UNITED STATES
NUCLEAR REGULATORY COMMISSION
WASHINGTON, D. C. 20555

SUBJECT: DAVIS-BESSE---STEAM AND FEEDWATER RUPTURE CONTROL SYSTEM

Reference: NRC memorandum, Thompson to Denton, "Preliminary
Review of the Design and Performance of the Davis-Besse
Feedwater and Related Systems", July 2, 1985

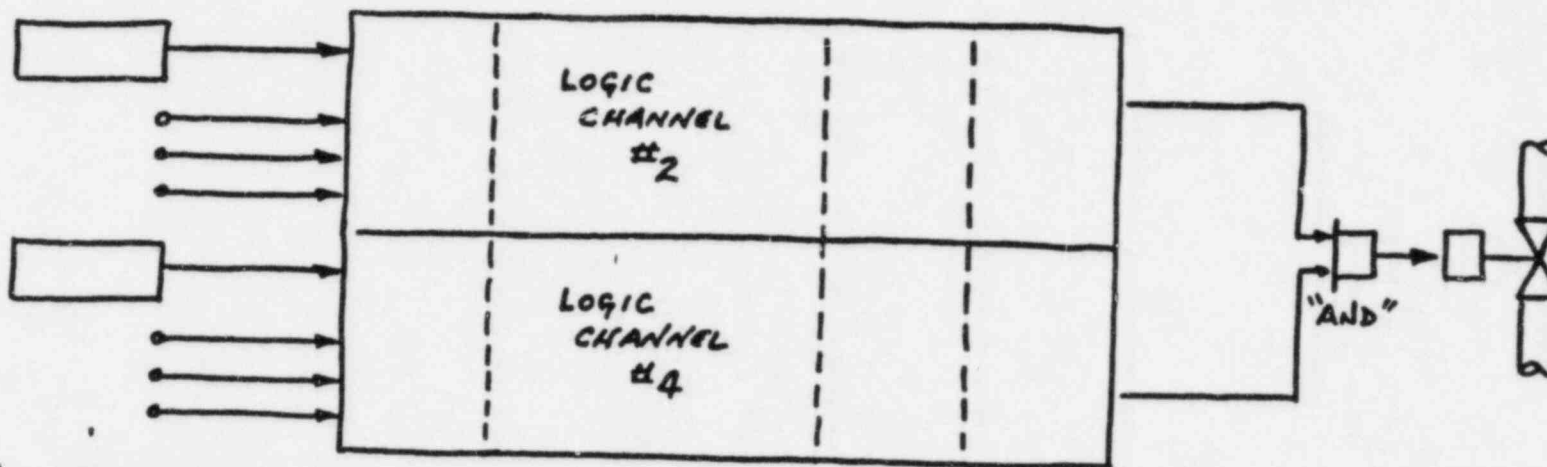
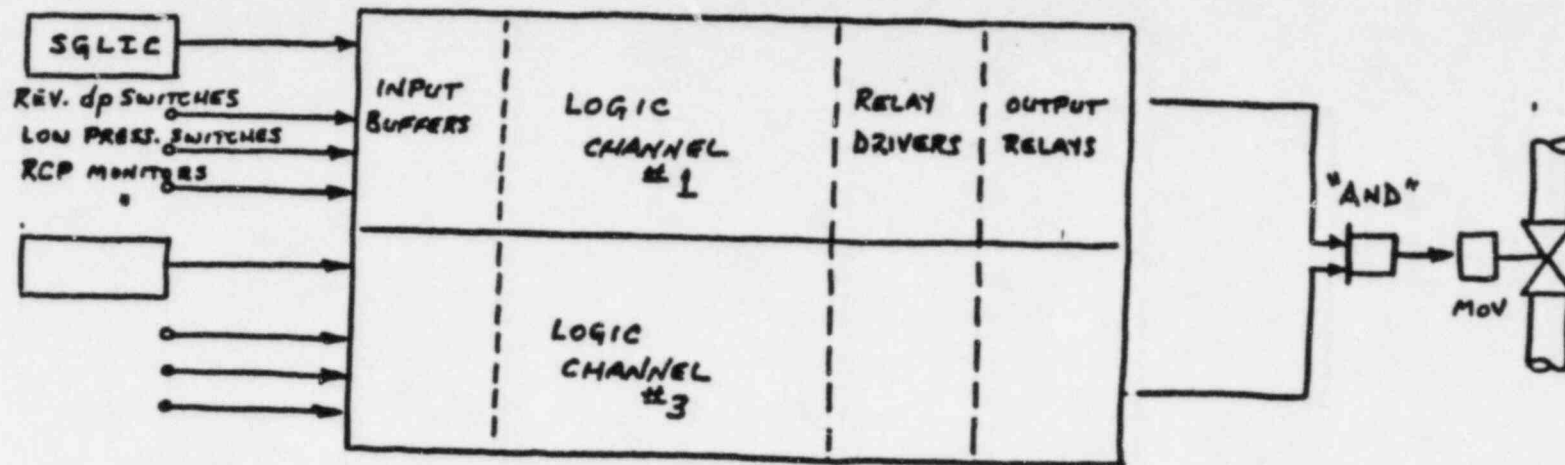
The actuation control scheme for the OTSG #1/AFW isolation valve, AF-608 has been chosen to illustrate the final actuation logic of the SFRCS, as shown in Figure 4.11. The scheme for valve AF-608 illustrates the two-out-of-two logic. Figure 4.11 shows also the bypass contacts around torque switches, which are believed to have caused this valve to fail during the June 9, 1985 event. Further, the figure is a useful reference when considering the vulnerability of the SFRCS to a single failure, as discussed in Section 5.3.

Figure 4.11 is simplified to show only the automatic-open and automatic-close circuitry. Normally, isolation valve AF-608 is open. If the closing torque switch is bypassed, if Actuation Channel #1 is fully tripped (logic channels #1 and #3) due to low pressure being sensed for OTSG #1, and if the "close inhibit" feature is not actuated, then both closing control relays would be operated and the isolation valve would go closed.

The combination of the low pressure full actuation and the "close inhibit" is logically equivalent to providing a close signal anytime OTSG #1 has low pressure. This results from K301 and K303 remaining untripped (energized, contacts closed) anytime OTSG #1 has low pressure. Conversely, if OTSG #1

never had low pressure, or if the low pressure condition later clears itself (recovers), or if the low pressure logic is bypassed (overridden), then the "close inhibit" function would be operative. However, under this condition, the logical arrangement is such that valve closure is always inhibited, regardless of level in either OTSG and pressure in OTSG #2. The licensee stated that he is currently re-reviewing this logic feature.

The "close inhibit" was a modification added by the licensee, himself, and that
The automatic opening (including re-opening) scheme for this isolation valve is much more straightforward. If the valve is not already at the full-open limit switch setting, and if the opening torque switch is bypassed, then a full trip of Actuation Channel #1 (logic channel #1, K301A; and logic channel #3, K303A, tripped) will open the isolation valve. The necessary logic for K301A (and K303A) is that, when OTSG #1 does not have low pressure, one of the OTSGs must have low level or OTSG #2 must have low pressure. During the June 9, 1985 event, when the inadvertent manual low pressure actuation were reset, low level existed for both OTSGs. Therefore, the OTSGs/AFW isolation valve, AF-608 should have re-opened automatically, but it did not.

FIGURE 4.6 SFRCS BLOCK DIAGRAM

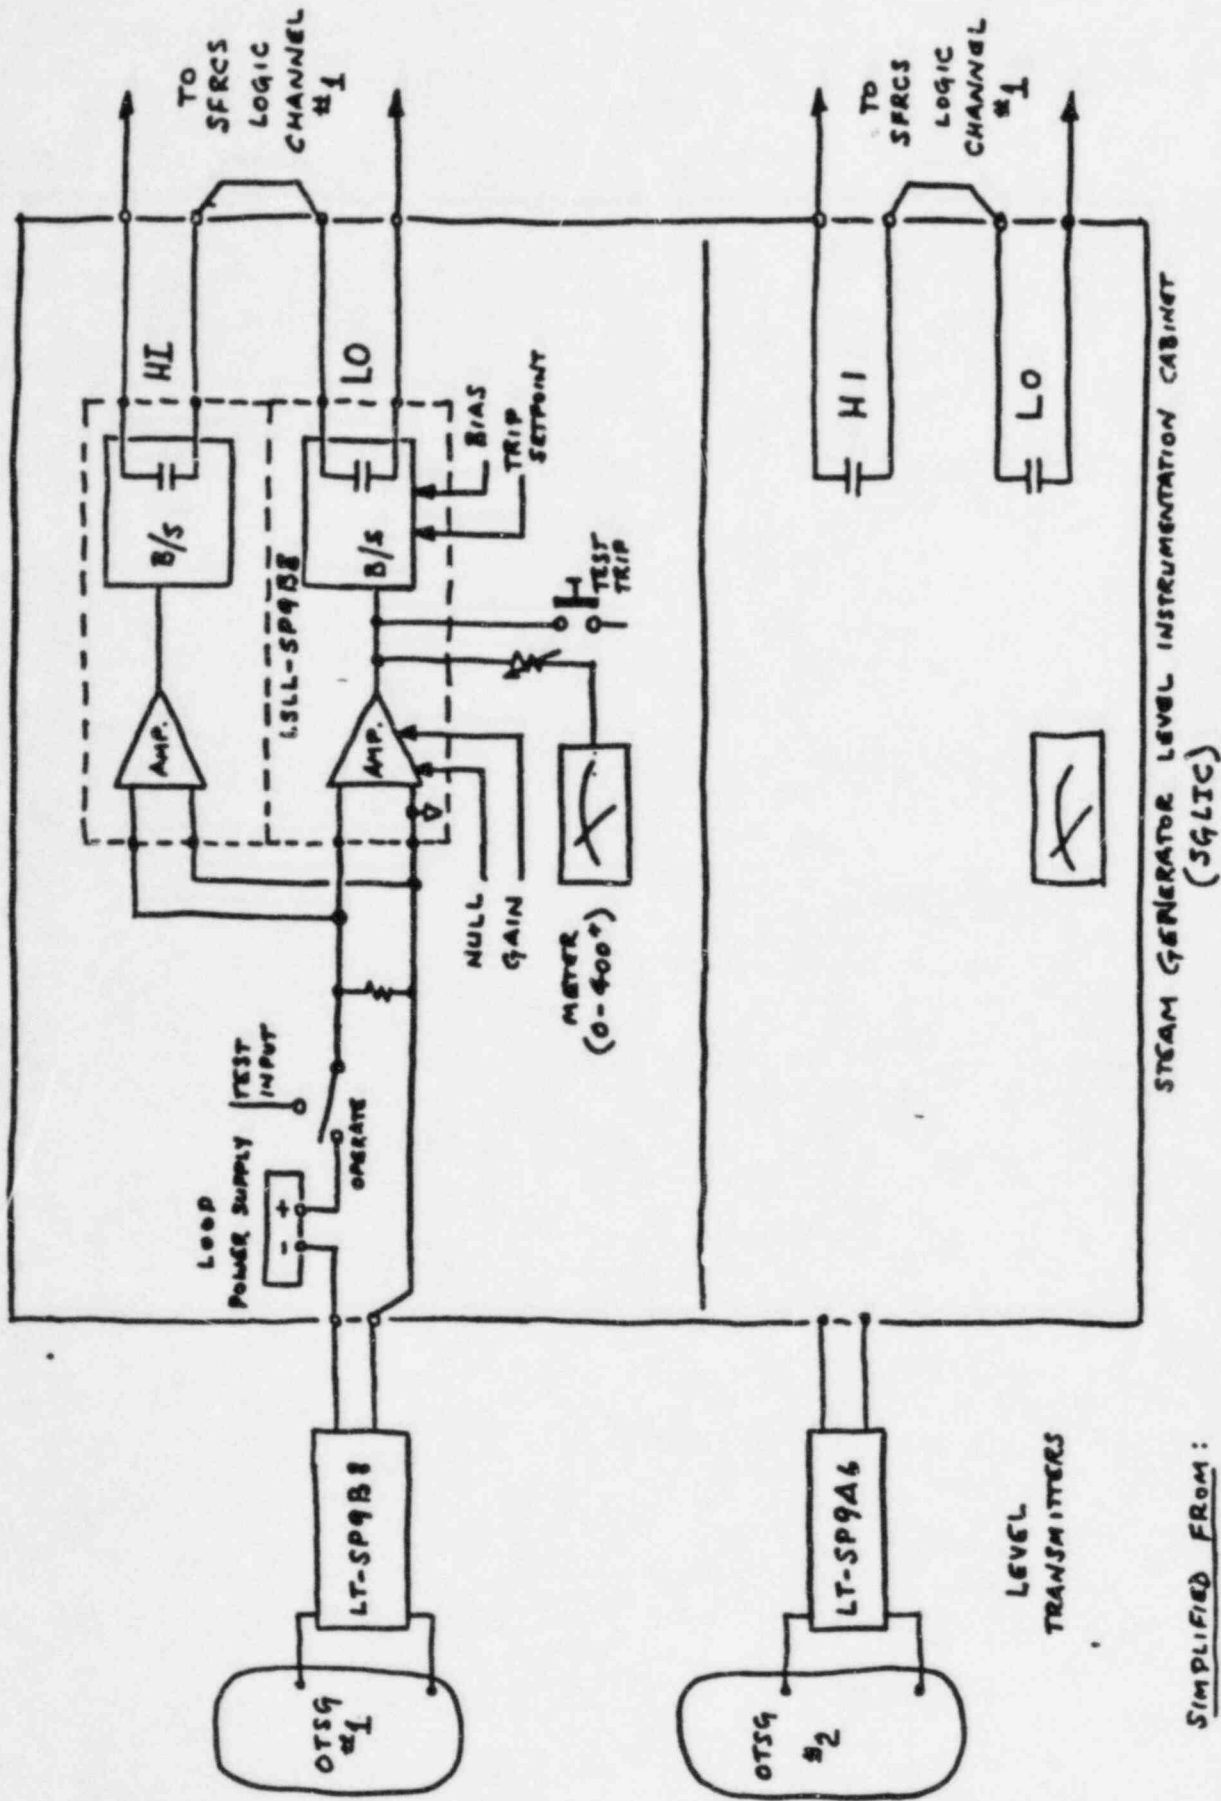
Contrary to USAR (Section 7.4.1.3.3), the SFRCS actuation channels are not redundant in the sense that one channel should be able to perform the functions of the other, in the event of a single failure. Actuation Channel 1 provides output signals primarily to equipment associated with loop #1; Actuation Channel 2, to equipment associated with loop #2. For example, the SFRCS system Actuation Channel 1 outputs (RCS 201,203) cause the OTSG #1/AFW isolation valve (AF-608) to close, and Actuation Channel 2 outputs (RCS 202,204) cause the OTSG #2 AFW isolation valve (AF-599) to close.

Figure 4.6 depicts the channelization of the SFRCS. There are two Actuation Channels, which each contain two identical logic channels. One logic channel is ac powered and the other logic channel is dc powered, within each Actuation Channel. The field wiring at the actuated equipment is such that generally

As shown on the SFRCS block diagram (Figure 4.6), each logic channel has a separate output. The field wiring of the controls for each SFRCS-actuated piece of equipment determines what combination of logic channel signals would actuate that equipment. In a few cases (such as the atmospheric vent valves), a single logic channel signal of an Actuation Channel is sufficient (i.e., a "partial trip" condition). For the special case of the MSIVs, both of the logic channel signals ("full trip") are necessary to trip the MSIVs. However, either SFRCS Actuation Channel can trip both MSIVs.

FIGURE 4.7 SFRCS LEVEL INSTRUMENTATION

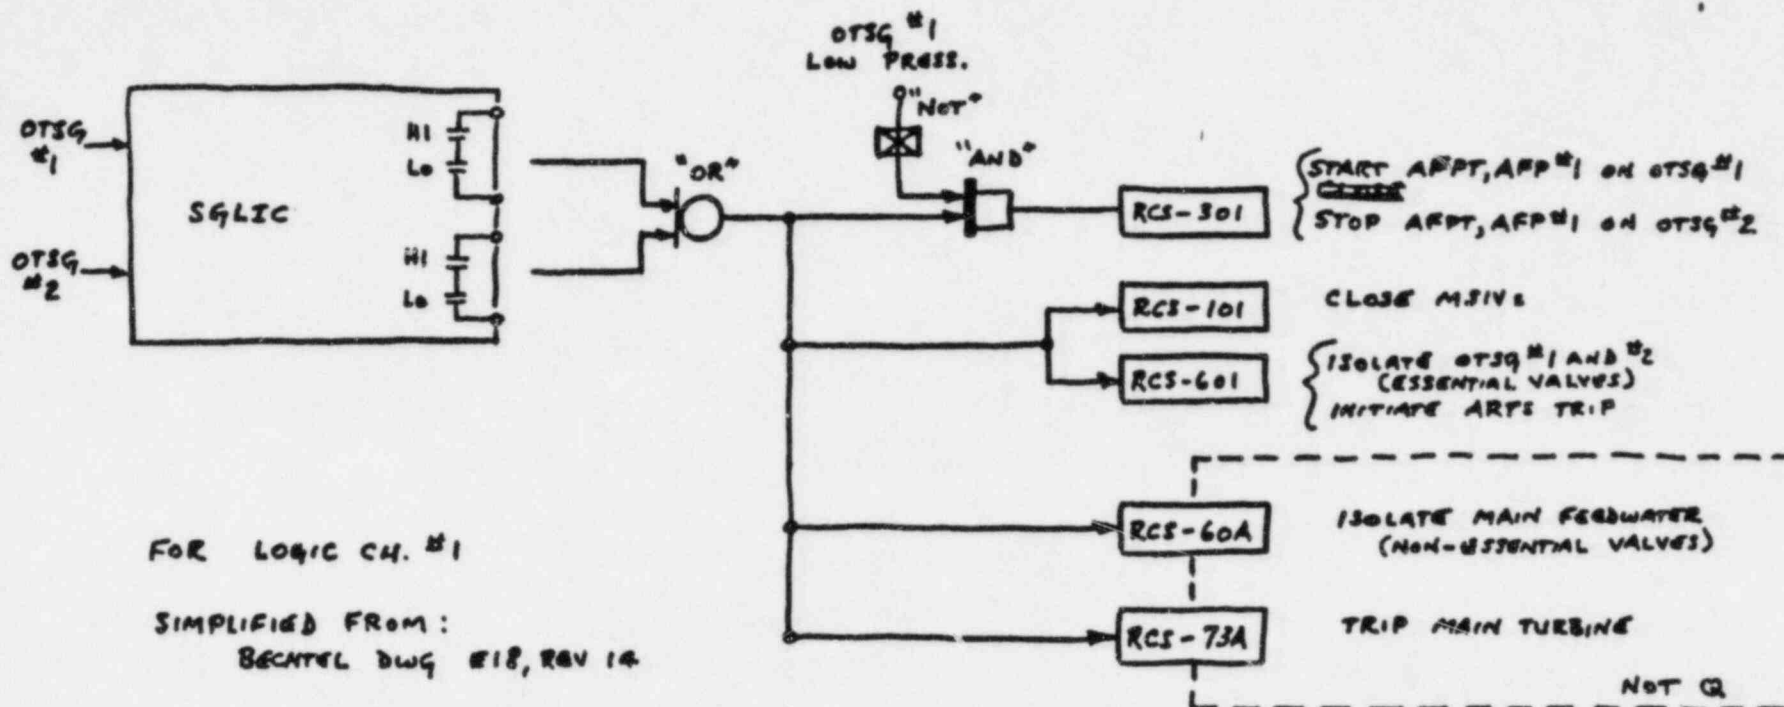
Figure 4.7 depicts the OTSG level instrumentation associated with the SFRCS. Except for a meter mounted on the Steam Generator Level Instrumentation Cabinet ^(SGLIC), behind the control room area, these level channels provide no indication or control functions. The level transmitter output signal is monitored by a dual hi/lo bistable. Since the outputs of the bistable are wired ^{in series}, the SFRCS input is the same for either a high level or a low level condition.

6.3.2.2 The licensee stated that the low level bistables of the SFRCS level instrument channels were replaced with dual hi/low bistables and the hi/low output contacts were wired in series to provide a single output (i.e. single input to the SFRCS). The licensee stated that the SFRCS design was further modified to provide a block of the high level trip upon actuation of the "operating bypass" on low pressure. The acceptability of bypassing a level signal with a pressure bypass and the possible affect on the low level SFRCS are uncertain. The loss of automatic AFW actuation on OTSG low level would appear to be a reduction in the safety margin.

FIGURE 4.9 SFRCS OTSG LOW PRESSURE LOGIC

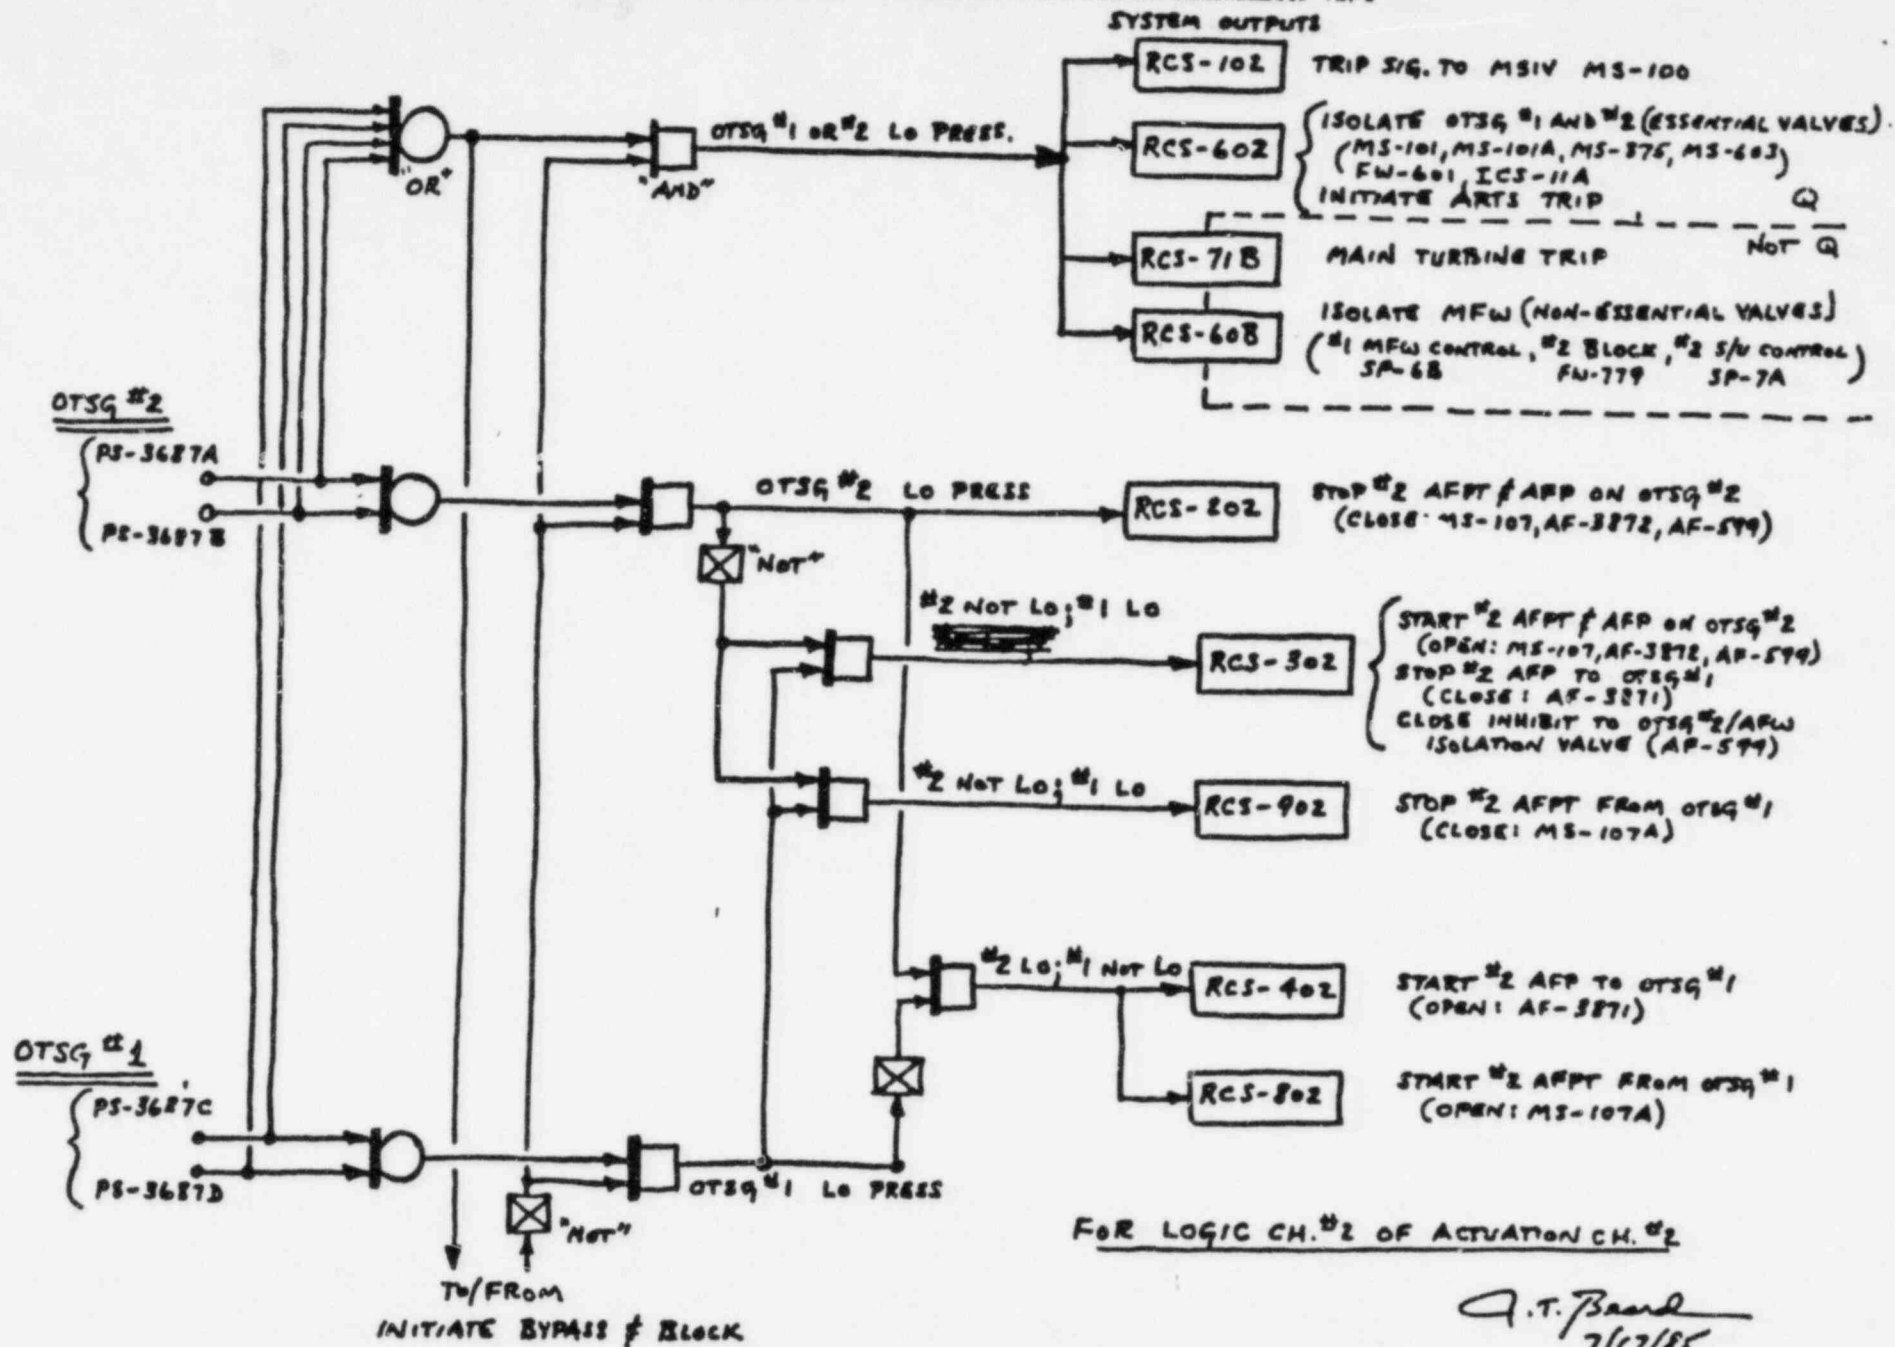
As shown in Figure 4.9, when any one of the four pressure switches (OTST #1 or #2) senses low pressure, its contacts would open and cause four immediate output signals to: (1) both MSIVs, (2) MFW isolation, including closure of the atmospheric vent valves, (3) reactor trip (via the ARTS), and (4) turbine trip systems.

Next in the figure, the low pressure signals are differentiated as to which OTSG is involved. If OTSG #2 has low pressure (at least initially), then AFW train #2 operation on OTSG_A^{#2} would be stopped. If OTSG #2 does not have low pressure (or later recovers its pressure) and ~~OTSG~~^{OTSG} #1 does have low pressure, then AFW train #2 would be started so as to draw steam only from, and provide feedwater only to, OTSG #2. Operation of AFW train #2 on OTSG #1 would be stopped. If OTSG #2 does have low pressure and OTSG #1 does not have low pressure (or later recovers its pressure), AFW train #2 would be started so as

to draw steam only from, and provide feedwater only to, OTSG #1. It should be noticed that this Channel does not provide output to AFW train #1.

FIGURE 4.10 SFRCS "INITIATE BYPASS AND BLOCK" LOGIC

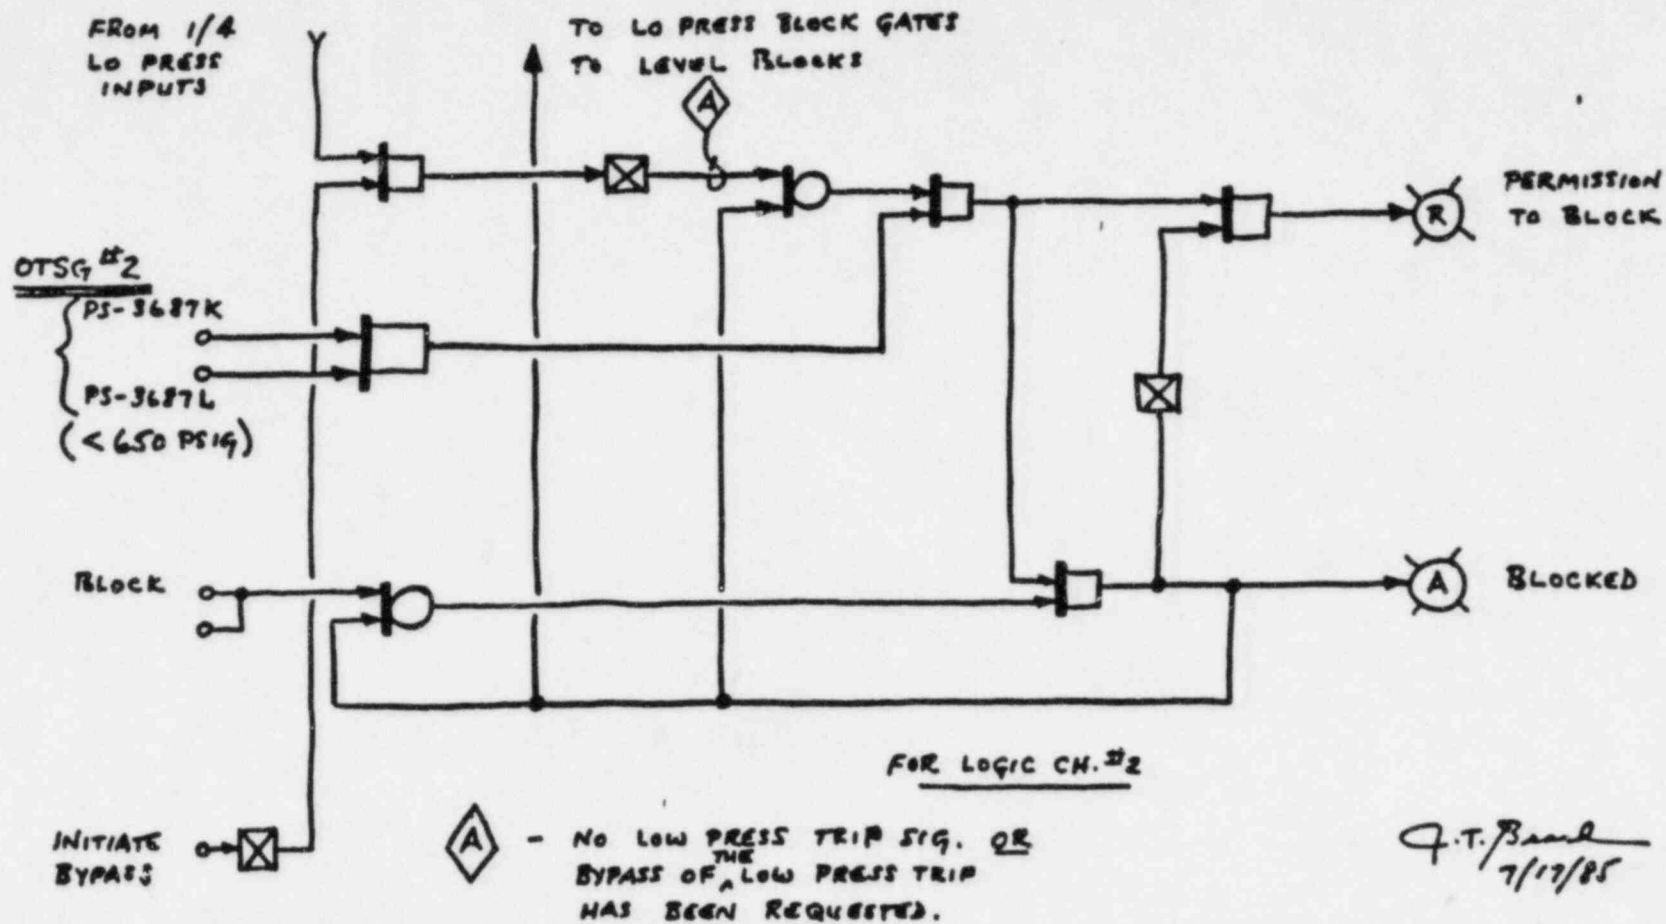
Figure 4.10 illustrates the "Initiate Bypass and Block" scheme, which is a feature included in the SFRCS as an "operating bypass" to allow normal cooldown without a low pressure actuation. The required safety function is that the block and bypasses be automatically removed as the plant returns to power (i.e., OTSG pressure greater than 650 psig). For an easy understanding of this logic, enter the figure at the point labelled with an "A" inside a diamond, with the presumption that none of the four low pressure switches has tripped (at less than 612 psig). Then, if both of the OTSG pressure switches are below the 650 psig, the "permission to block" (i.e., prevent a trip actuation) red light would come on. Next, when the "block" switch is operated, the following actions would occur:

(1) the "permission to block" light would go off, (2) the "blocked" amber light would come on, (3) a seal-in signal is provided back to point "A", (4) a seal-in signal is provided back to the "block" switch input, and (5) block actuation signals are sent to the low pressure logic and to the high level circuitry. Notice that, when either pressure switch senses a pressure greater than 650 psig, the block logic would be automatically interrupted by an "AND" gate within the seal-in loops.

If, on the other hand, one or more of the low pressure switches (less than 612 psig) have tripped, an additional step is required to bypass the actuation signal (i.e., override, or defeat, an already existing and not cleared trip signal).

If the "initiate bypass" switch is first operated, the same block/bypass signals back to the low pressure and level logics can be actuated (as discussed above), so long as the pressure remains below 650 psig.
